**PLANNING COMMISSION MEETING**  
**LOCATION: 7527 HIGHLAND ROAD, WHITE LAKE, MI 48383**  
**(FORMER WHITE LAKE LIBRARY)**  
**THURSDAY, DECEMBER 02, 2021 – 7:00 PM**

**RE: Four Corners Outlot- Preliminary Site Plan, Final Site Plan/Final Engineering Plan Review – 2<sup>nd</sup> Review**

**RE:** Four Corners Square – Retail Center #2  
Preliminary and Final Site Plan – Review #2

White Lake Township,  
Oakland County, Michigan  
**CONSTRUCTION/SITE PLAN DOCUMENTS**  
Prepared For  
**4 Corners Square LLC**  
PART OF THE SE 1/4 OF SECTION 36,  
WHITE LAKE TOWNSHIP,  
OAKLAND COUNTY, MICHIGAN

**NFE JOB NO.** SHEET NO.  
**J635-03** **L1**

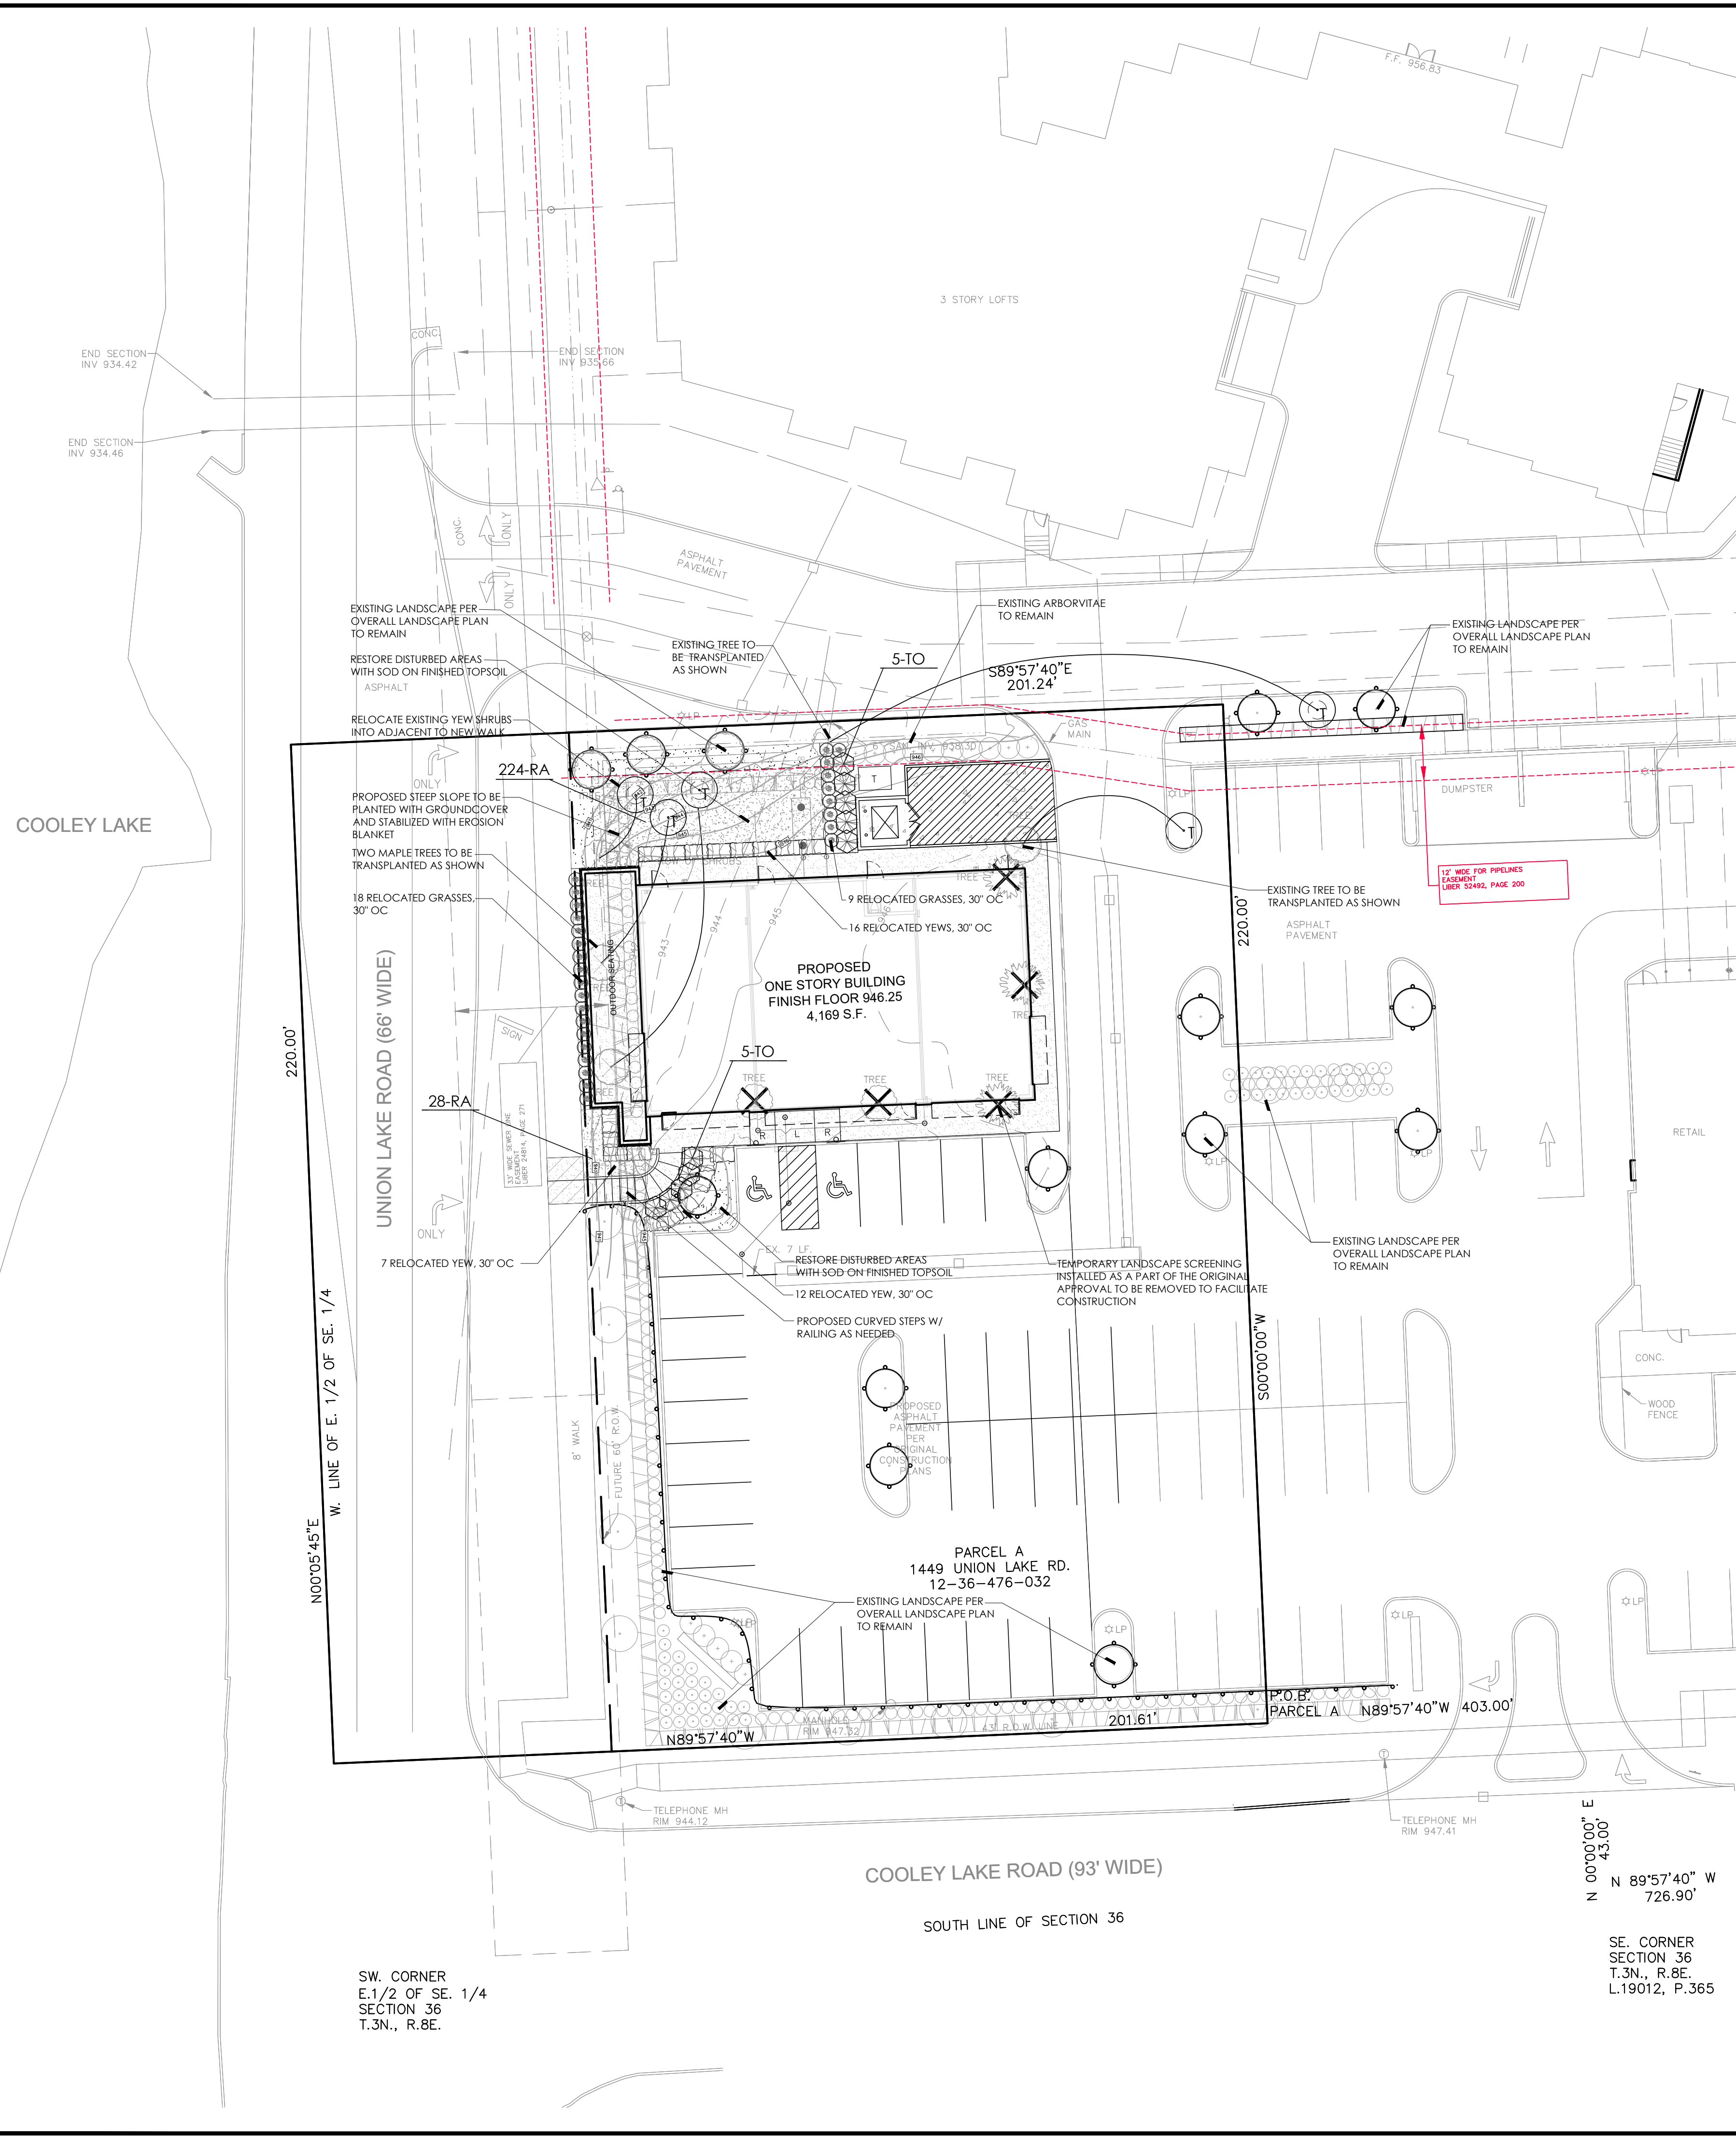
1. *It is not clear as to whether the two trees north of the proposed transformer location are proposed or existing. The trees as shown on the plan are too close to the proposed water and sanitary sewer lead extensions and will need to be relocated preferably at a distance of 10' horizontally from the proposed leads. **Comment addressed.***

2. *It should be verified with the easement owner of the pipeline as to whether trees are allowed within the easement.* **Comment addressed.**

**3 TYPICAL BOLLARD DETAIL**  
 A.501 NOT TO SCALE

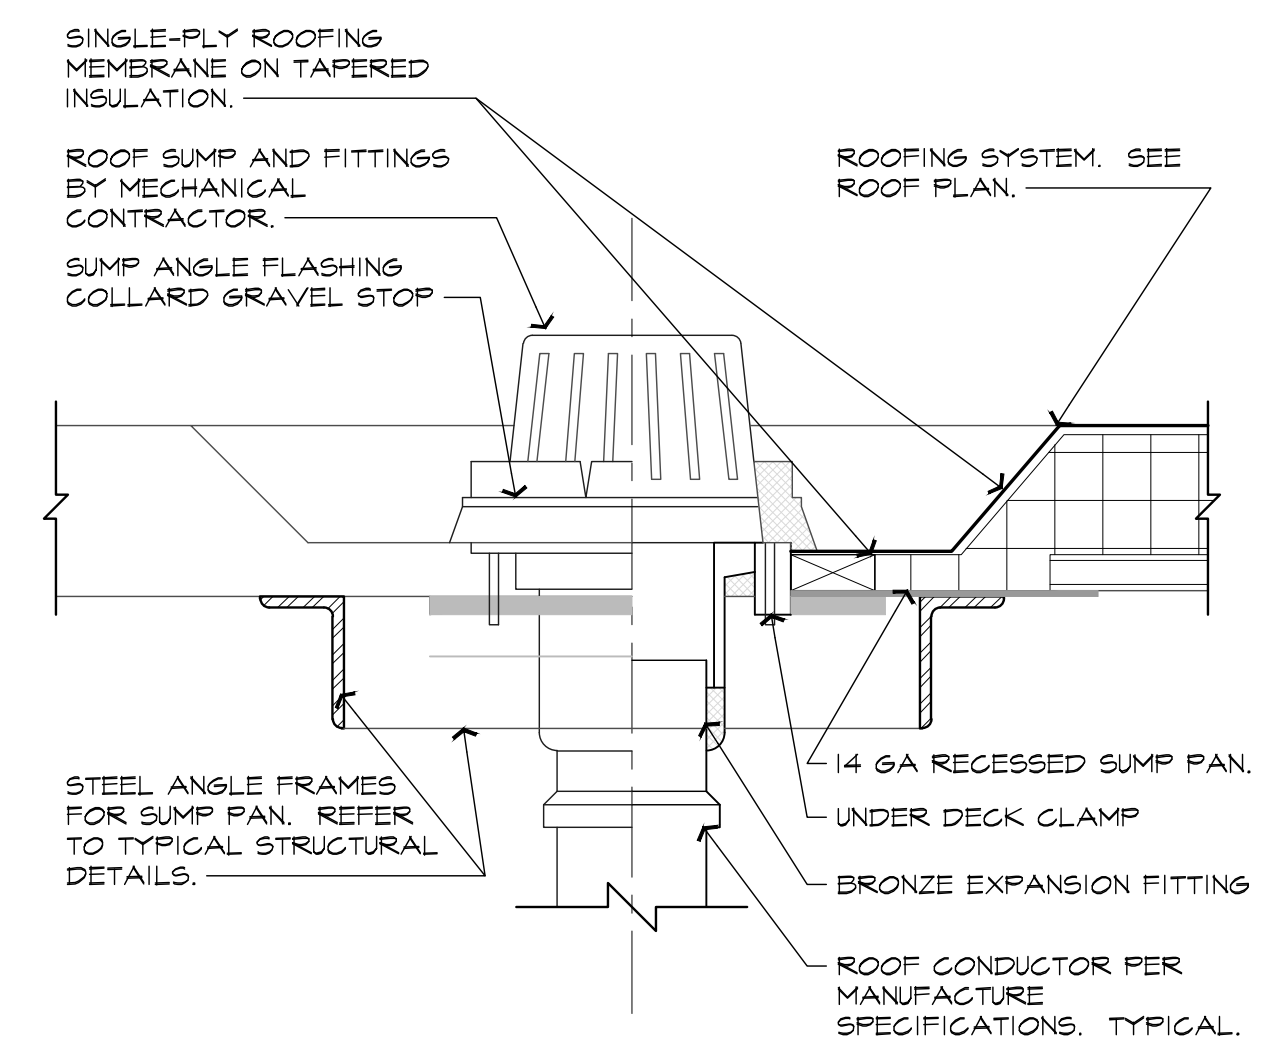
5. *The bollards for the dumpster enclosure shown on Sheet C7 will need to be 6" diameter instead of 4" diameter and also on Sheet A.502 where 5" diameter bollards are proposed. **Comment partially addressed. The bollard diameter is now correct (6") on Sheet C8; note that we did not receive Sheet A.502 as part of this submittal. The diameter of the bollard shall be revised on Sheet A.502 as well.***
